September 6, 2024

**Re: Initial Submission Review:** Windler Midtown – Site Plan (Neighborhood Plan Pilot)  
**Application Number:** DA-1707-38  
**Case Numbers:** 2024-4021-00

WINDLER MIDTOWN  
NEIGHBORHOOD PLAN

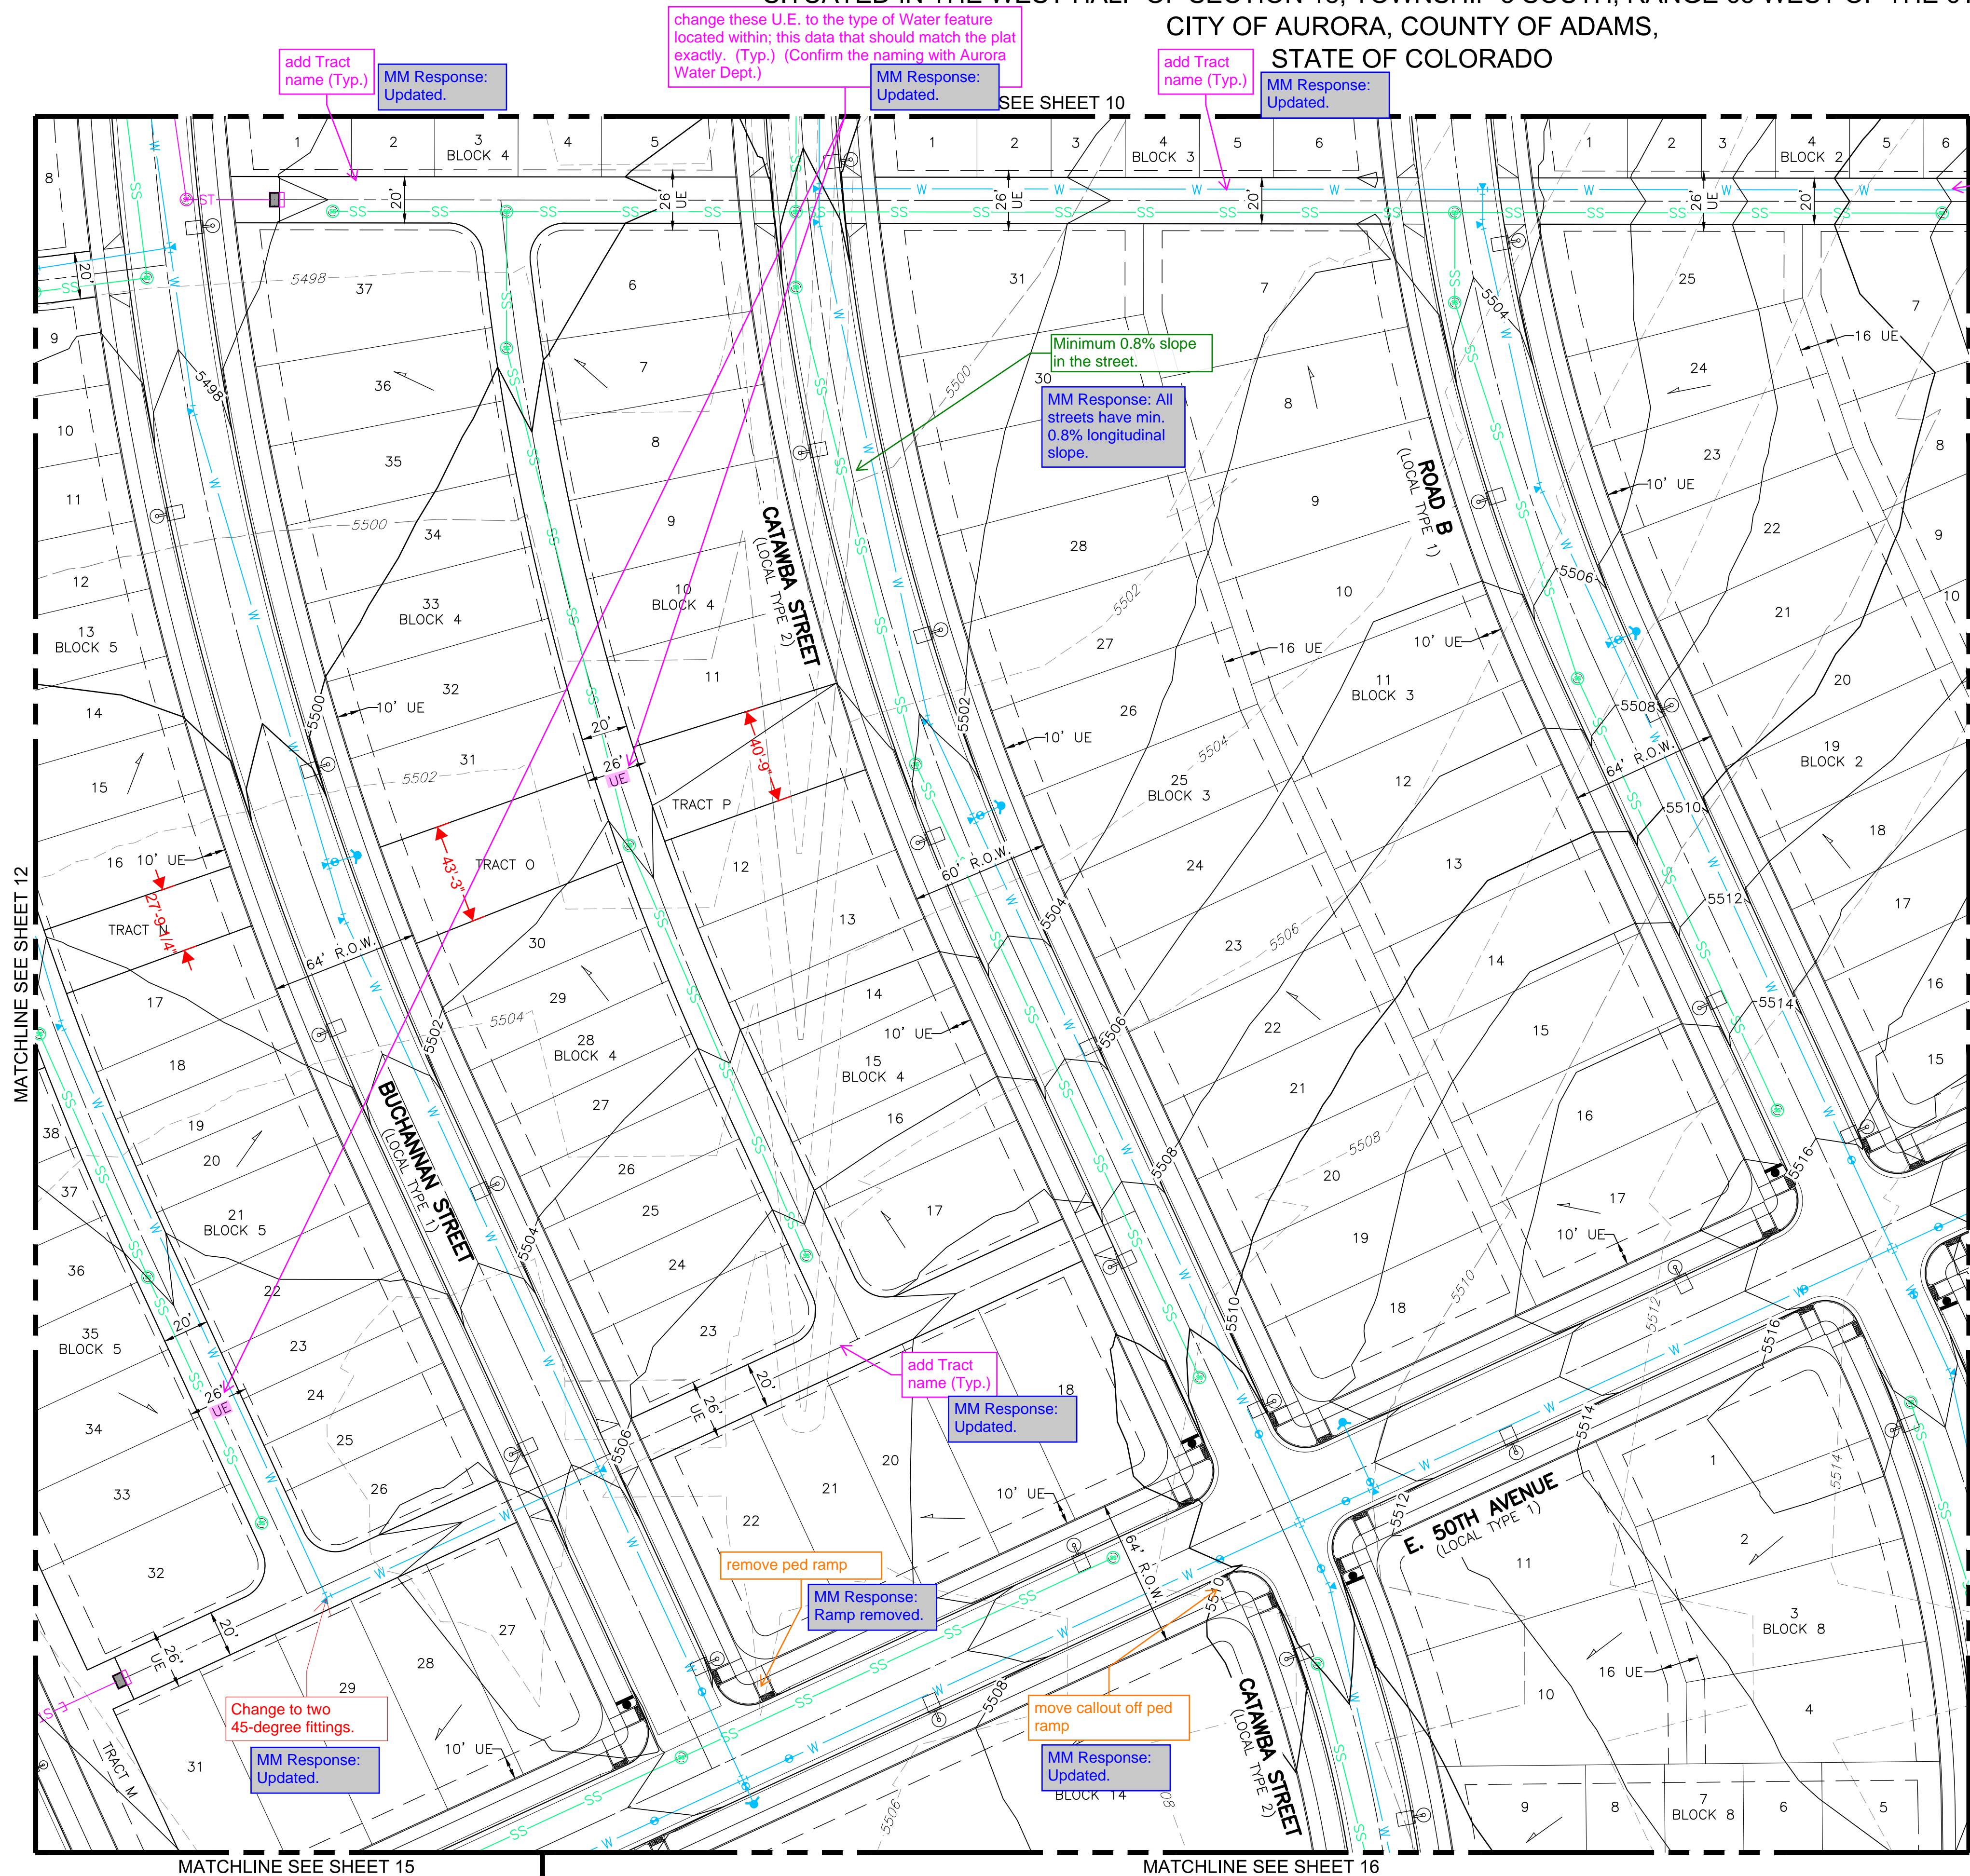
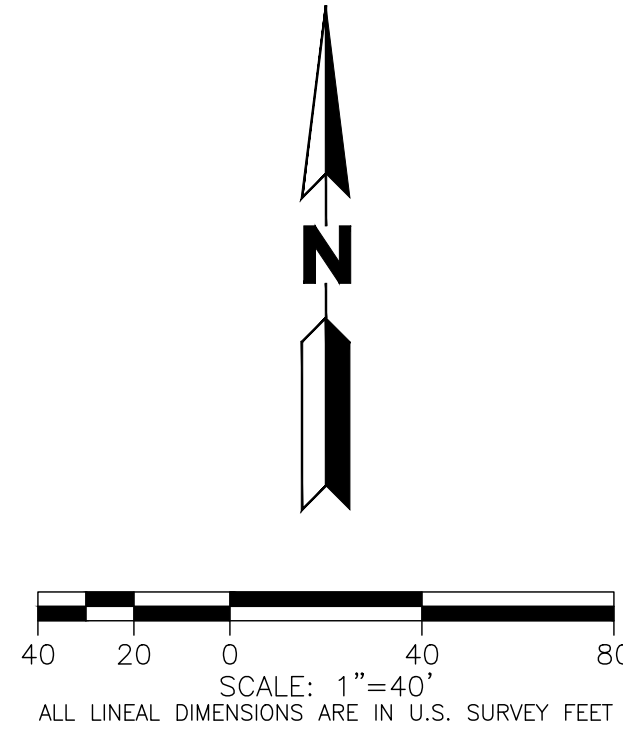
add Tract  
name (Typ.)  
MM Response:  
Updated.

add other  
abbreviations here  
MM Response:  
Abbreviations  
added.
